PRODUCT/PROCESS CHANGE NOTICE (PCN)

PCN #: **TB1711-03** DATE: **December 7, 2017**
 Product Affected: **WLCSP-40, 52, 54**
 (Refer to Attachment II for affected part#)
 Date Effective: **March 7, 2018**

ATTACHMENT I - PCN #: TB1711-03

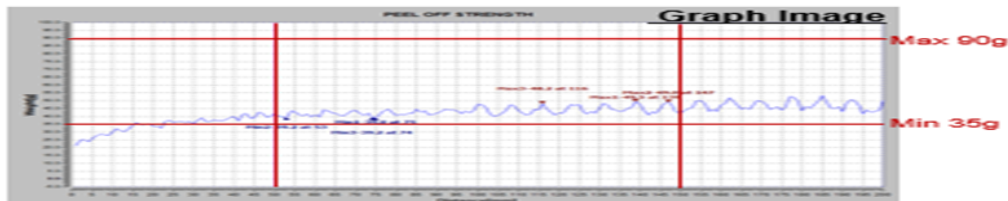
Sealing & Peeling Quality : Pass

Item	E-pak eH52 (Heat Seal Type)	Result
Sealing Image		Pass

Peeling Image		Pass
